CITY OF ST. PETERSBURG, FLORIDA
PLANNING AND DEVELOPMENT SERVICES DEPARTMENT
URBAN PLANNING AND HISTORIC PRESERVATION DIVISION

STAFF REPORT

Community Planning and Preservation Commission
Certificate of Appropriateness Request

Case No.:	18-90200057
Address:	687 Central Avenue
Legal Description:	ORANGE PARK ADD (HISTORIC LANDMARK) BLK A, LOT 5 & W 4 FT OF LOT 4 LESS S 26.3FT OF EACH FOR RD R/W
Parcel ID No.:	19-31-17-64530-001-0050
Date of Construction:	1924
Local Landmark:	State Theatre (historic Alexander National Bank), HPC 91-02
Owner:	Landmark Theatre Group, LLC
Agent:	Jack Bodziak, AIA
Request:	Request for the approval of a Certificate of Appropriateness for the alteration of a local historic landmark

Figure 5: Proposed fenestration from application. New windows darkened.

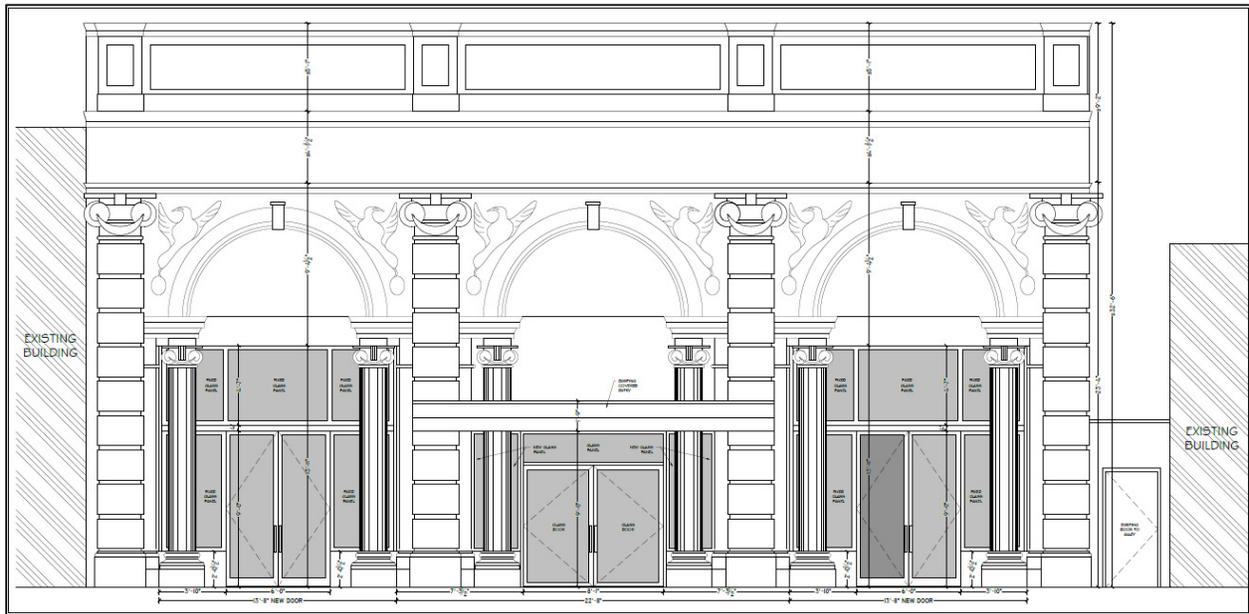
The proposed windows do not appear to meet this criterion, though similar versions of the product line are available with insulating glass.

Although specific information on proposed window setback is not included in the application, the proposed windows do appear to follow the historic setback, running behind the façade's columns. Replication of the historic window depth should be a Condition of Approval.

While not an exact replication, the proposed windows visually approximate the 1950 windows.

The initial application for this COA initially included a full restoration of the façade windows to replicate their 1924 configuration. However, if a replication of the original "State" sign is approved, the retention of the stucco infill within the round arches is actually a more authentic configuration, as it reflects the postwar changes to the building. This infill appears to have been, and, indeed, remains necessary because of the construction of the interior balcony, which is being restored.

The 1950 windows can be seen in Figure 2 to have rested above low knee walls and feature primary entry doors at the center bay. There are secondary doorways at the first and third bays, where windows extend upward to end in alignment with the tops of the impostes from which the round arches begin their curvature. Staff recommendation is to replicate this historic upper terminus. The proposed doors appear to be taller than those seen in Figure 7, and there are slight changes to the proposed upper light configuration and knee wall heights, but these changes will not significantly impact the overall presentation of the building.

Because of the presence of the marquee in photographs following the 1950 theatre conversion, it is difficult to see whether the space behind the marquee was glazed or infilled with stucco, as proposed. This is a minimally visible location, due to the proposed replication of the "V" shaped marquee, so approval of the central bay as proposed is recommended.

1. Window openings at first and third bays be extended upward to align with round arches as shown in photographs taken following the subject property’s 1950 renovation;
2. Windows and doors are to be set back in wall plane and run behind columns, as shown historically;

Figure 6: Proposed signage from application

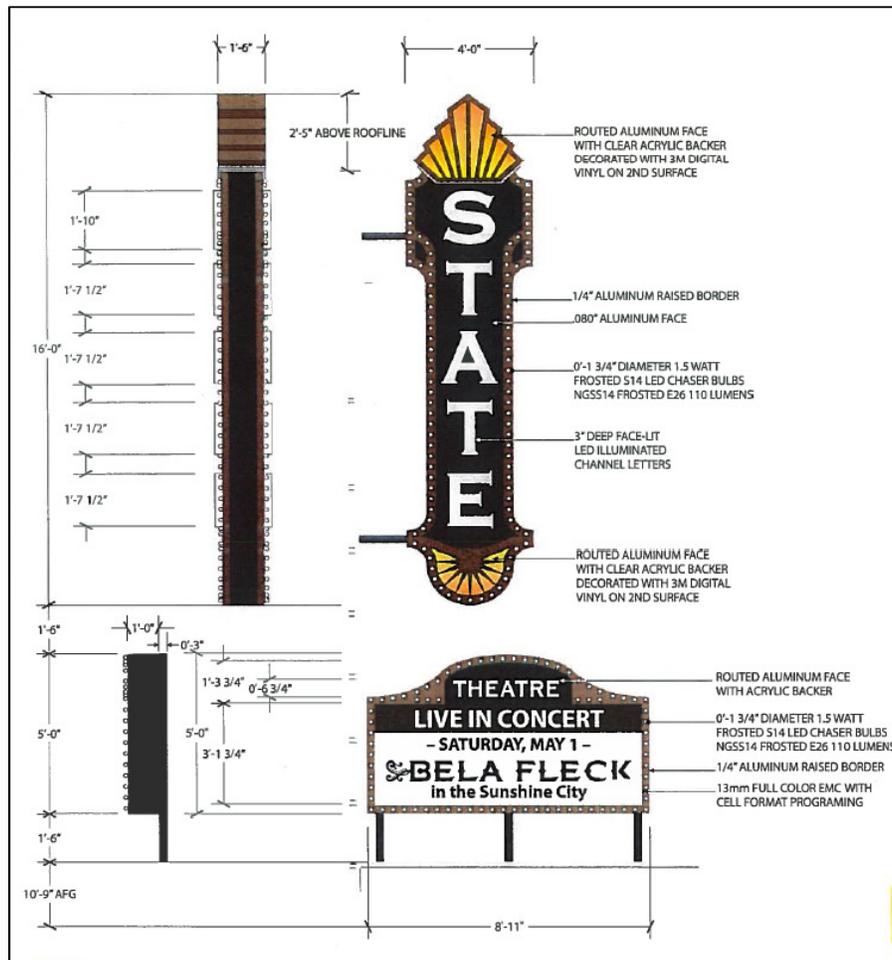
The project does not appear to successfully meet this criterion as proposed, primarily because of the stylistic incongruity of the proposed signage. As addressed in the Conditions of Approval, a more streamlined aesthetic is recommended for these elements to recreate the 1950 signage.

Part of the propose project appears meet this criterion as proposed. As noted, the 1950 alterations are recommended for consideration by Commissioners as significant and character-defining elements of the subject property. With the recommended Conditions of Approval, the proposed windows will restore the 1950 configuration. Proposed ornamentation on the signage is out of context and a modified shape and style are proposed.

According to Zoning staff, the maximum allowable area of sign face for the 57’9” width of the façade would typically be approximately 102 square feet. The proposed signage will appear to total approximately 153 square feet, based on staff calculations from plans provided. The exact dimensions of the 1950 sign are unknown, but the replication of the sign shown in Figure 10 would allow additional square footage, since the “State” blade and marquee have been identified in St. Petersburg’s Inventory of Signs of Historic Significance. It is suspected that applying the following recommended stylistic changes will sufficiently decrease the sign face area, as well as create signage that more appropriately replicates the historic condition:

The proposed sign also features two faces of Electronic Message Centers (EMCs) at the marquee. Although the installation of EMCs within the boundaries of Local Historic Landmarks is generally not permissible, a COA may be granted for such by the CPPC in the case of performing arts venues such as the subject property. Due to the requirement that replications of signs of historic significance “must use historical materials and technologies, or use contemporary materials and technologies that visually match historical ones,” historic preservation staff does not support the approval of the introduction of EMC technology as part of the approval of the additional sign face square footage allowable for a replica sign

3. Sign to be modified to more accurately reflect a replication of the historic 1950 “State” blade and marquee:
 - a. Use straight rectangular shapes at both blade sign and marquees, rather than curved signs;

- b. Eliminate upper and lower “Sunburst” flourishes;
 - c. Eliminate “chaser bulb” borders of white lights surrounding each sign face;
 - d. Employ more streamlined sans-serif typeface at “State” blade;

- e. Restrict overall footprint, as seen historically:
 - i. Blade shall extend no more than 12 inches above existing roofline and make use of existing historic frame where possible;

- ii. Marquee shall not extend beyond front or side edges of awning;
 - iii. Marquee shall use interchangeable letters, rather than EMCs.
4. All work, especially masonry cleaning and repairs, undertaken in the course of this rehabilitation to employ the gentlest means possible;

Figure 11: “Night View” of proposed signage, from application

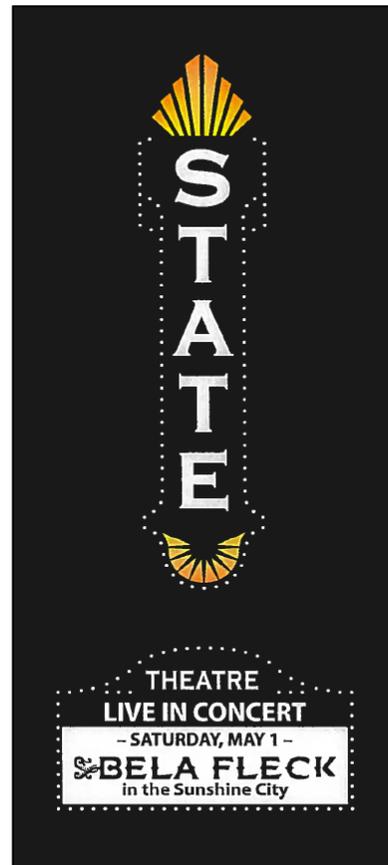
The proposed signage is stated to be a reconstruction of the 1950 blade sign and marquee. According to City Code Section 16.40.120.3.6 – Signs of Historic Significance,

- Use straight rectangular shapes at both blade sign and marquees, rather than curved signs;
- Eliminate upper and lower “Sunburst” flourishes;
- Eliminate “chaser bulb” borders of white lights surrounding each sign face;
- Employ more streamlined sans-serif typeface at “State” blade;
- Restrict overall footprint, as shown in Figure 12:
 - Blade shall extend no more than 12 inches above existing roofline;
 - Marquee shall not extend beyond edge of awning.

FRONT ELEVATION

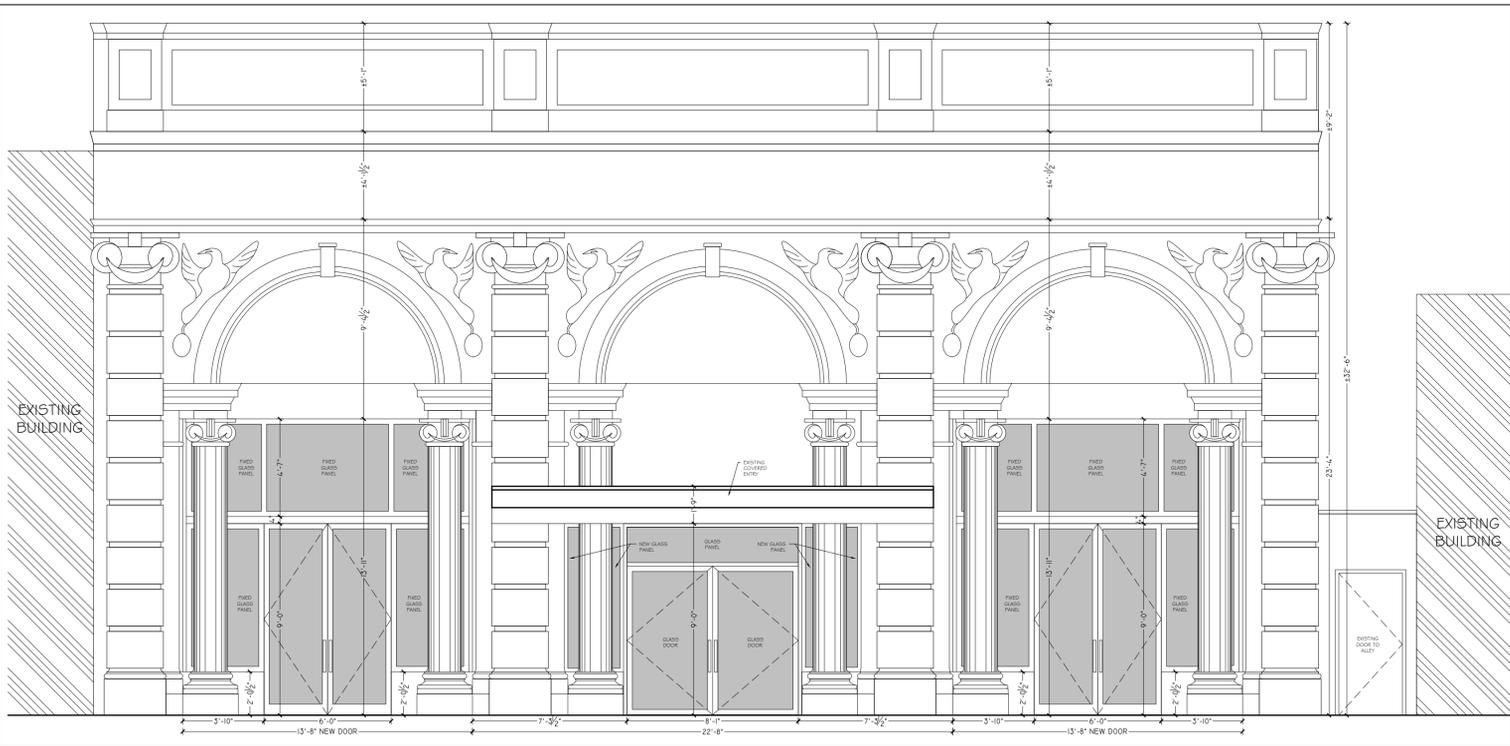
As the Architect-of-Record on the State Theatre , I have worked with the Owner and Contractor in an effort to restore the Glass Store Front to as close to its original configuration, as is practically possible. In an effort to make it as Historically Correct as possible, Kevin Chadwick, Boyd Construction and my Staff have put in considerable time attempting to recreate the original Glass Front Façade. Unfortunately we now realize the arched tops of the window Store Fronts are no longer Glass and are replaced with Stucco Panels for a reason.

In order to simply install the new Store Front up to the bottom of the Arch or make any Store Front Installation, we would be required to place an additional Steel Horizontal Support Beam creating an Anchor for the Store Front below that will provide sufficient Wind Load Resistance and conform to the current Florida Building Code.

I believe the Store Front Restoration in the attached Drawing is the smartest and soundest Solution that will bring us as close as possible to the Original Façade. If you wish to visit the Site and climb into the area at the top of the Arch, I will arrange it, however, I have attached photographs that fairly clearly represent the current conditions with the Concrete and the Red Iron.
